April 9, 2024
7:00 PM
Planning Board Agenda

Public Hearing of application for Amended Site Plan Approval, 11 Mirbeau Lane, submitted by Mirbeau of Beacon, LLC (Edward Kellogg).

Re: Mirbeau Subdivision, Site Plan and Special Use Permit – Amended Site Plan
11 Mirbeau Lane
Tax Parcel: 6054-13-001258, ±64.39 ac.
City of Beacon, NY

JOB #:	2021:051
DATE:	3/29/2022
SCALE:	1" = 40'
TITLE:	SP-3
SHEET:	5 OF 29

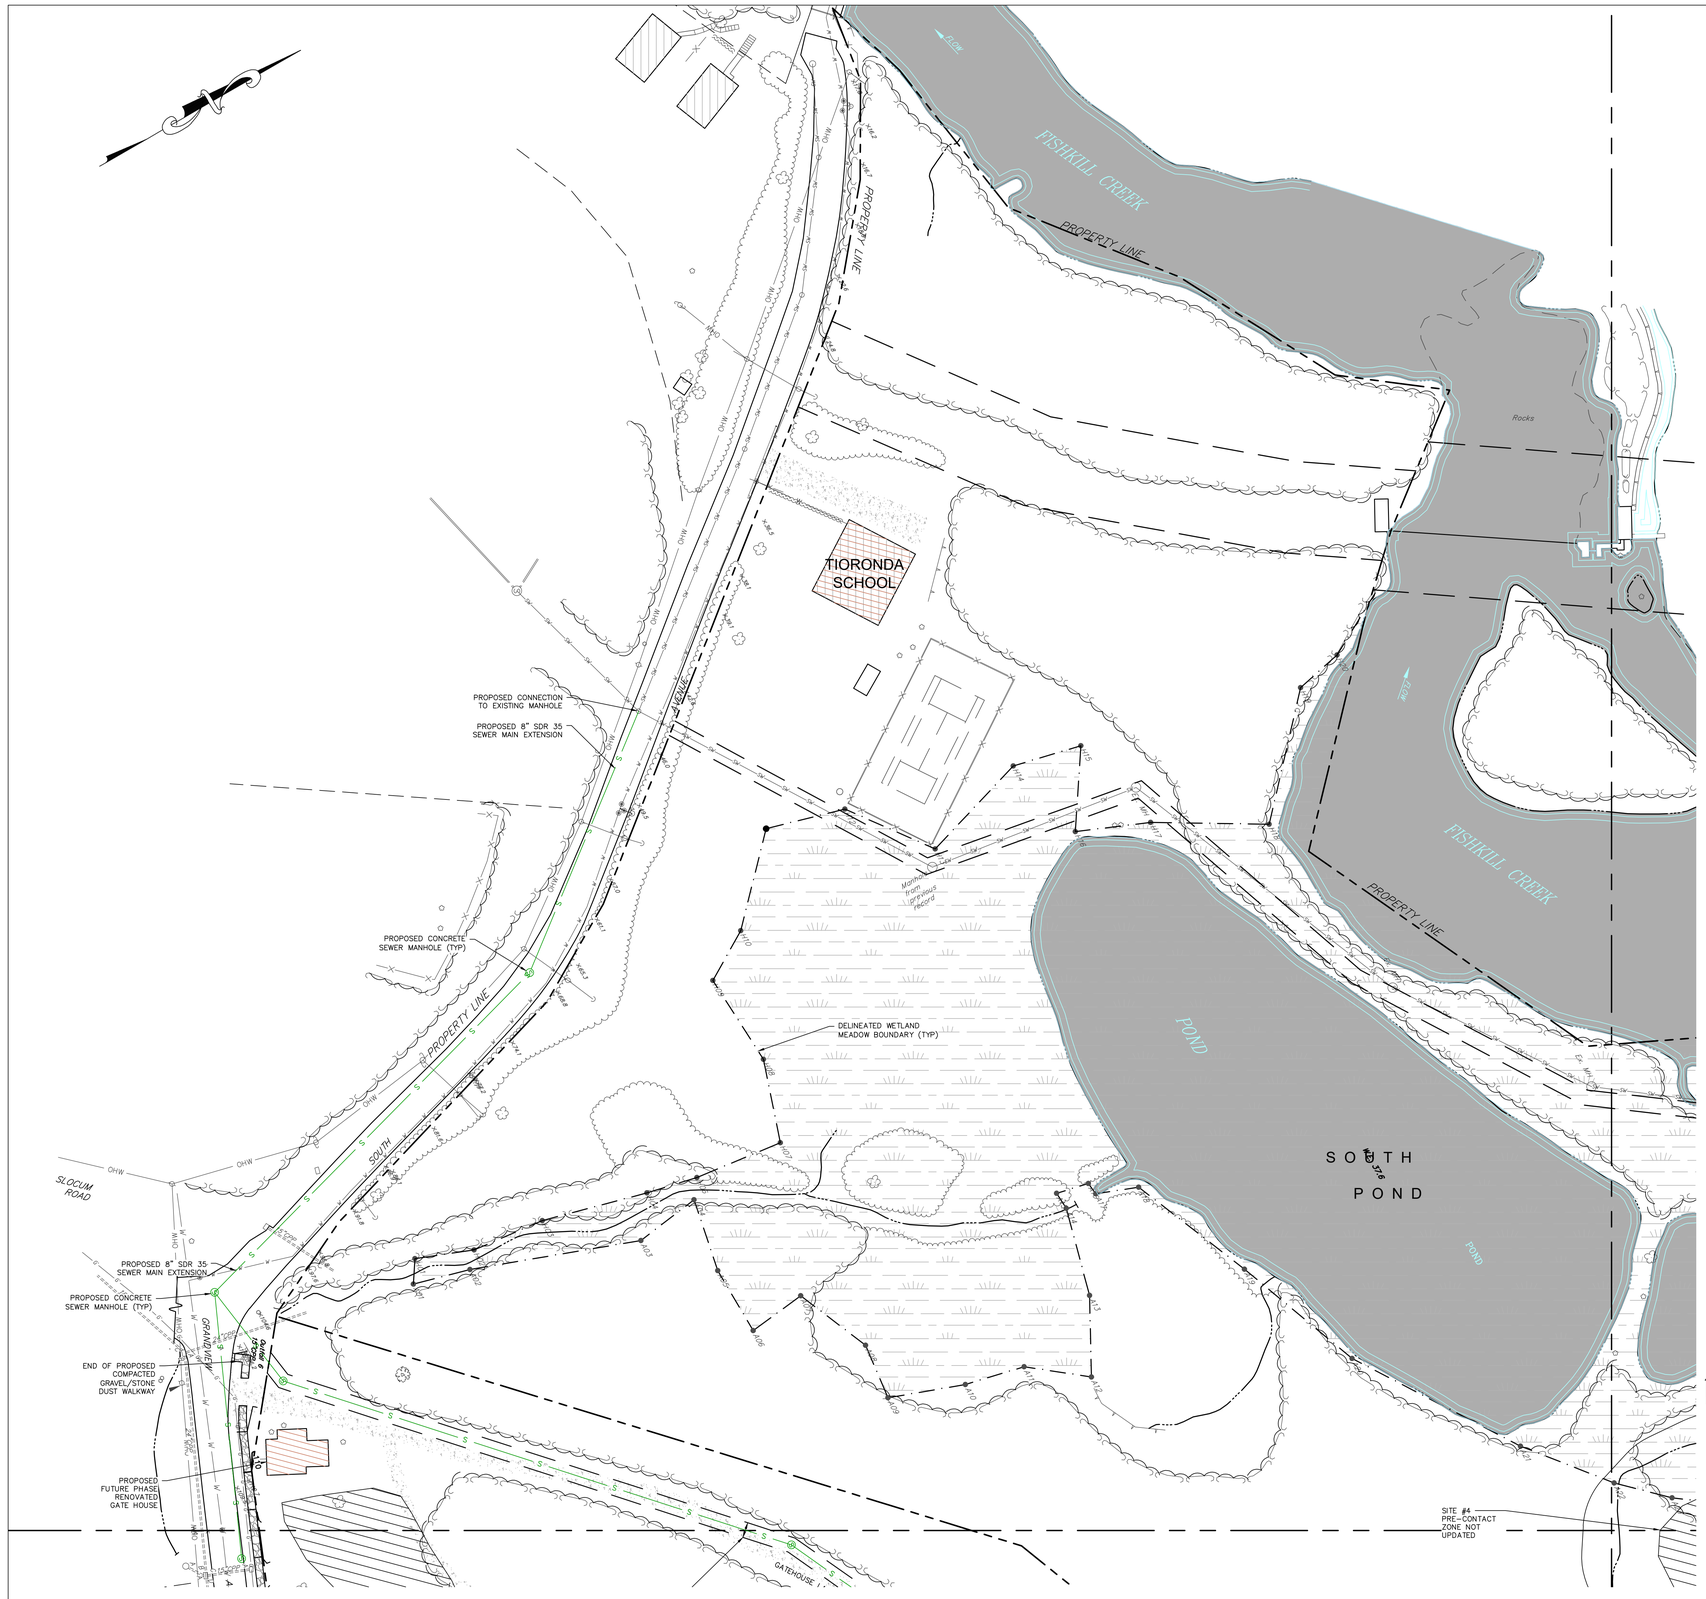
Sheet 4 of 29

1 **WATERMAIN PROFILE**
SCALE: SCALE-H=1"=50'
SCALE-V=1"=10'

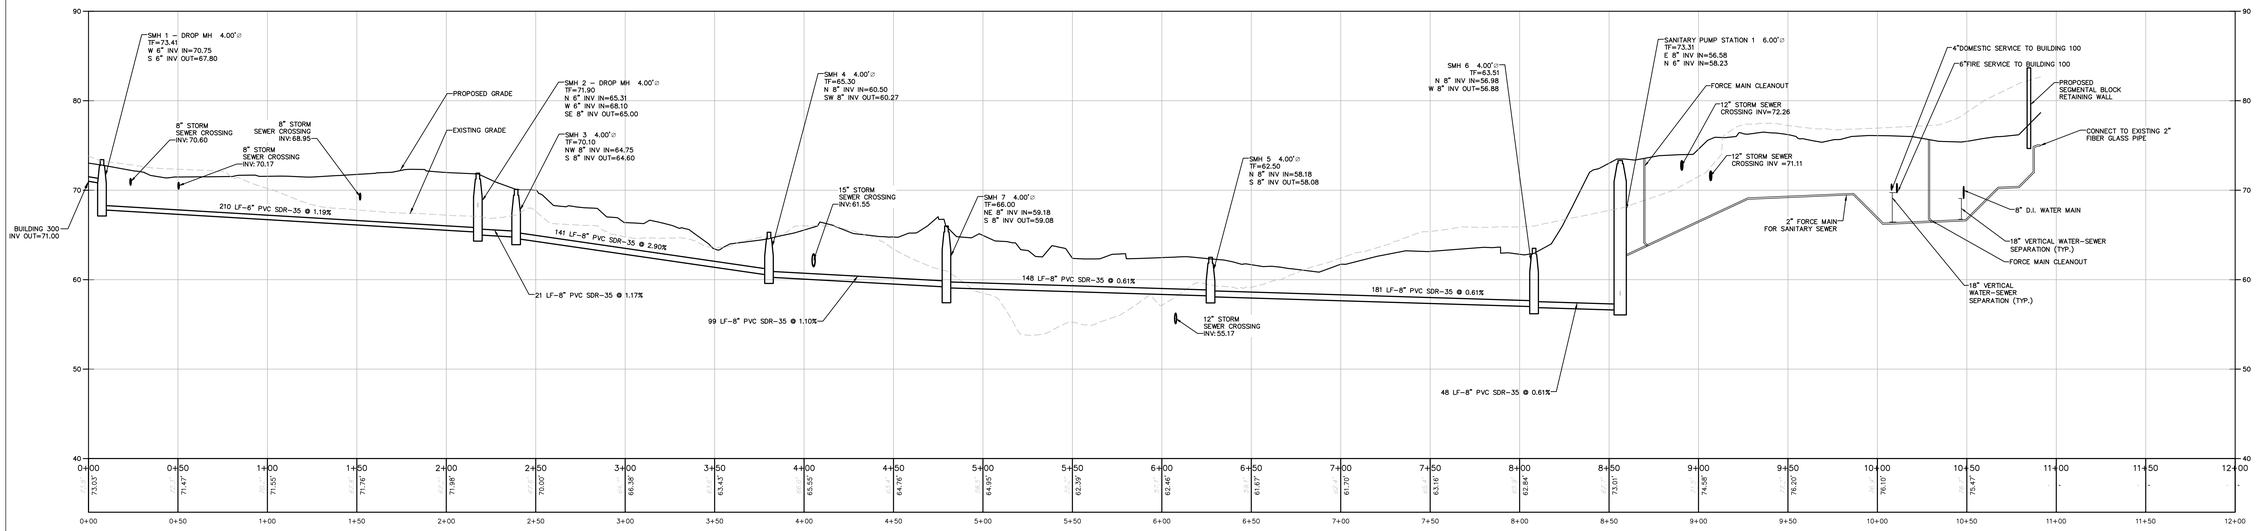
12. *Stationing shall be provided along the new sewer main routing, and the stationing for the previous sewer main location removed from the plan on sheet C160.*

13. *As the sewer line has shifted location, it is unclear what the sewer line and manhole to the left of Building 200 is need for. Sheet C160 should be revised to eliminate this manhole and sewer run.*

9. The numbering of the sewer manholes as presented on Sheet C160 should be in numerical order. At present, the sewer line runs from manhole 4 to manhole 7, and from there to manhole 5. This should also be corrected on the profile.

Response: The building 300 sewer line is located at the outdoor courtyard area connecting buildings 200 & 300. See sheet C160.
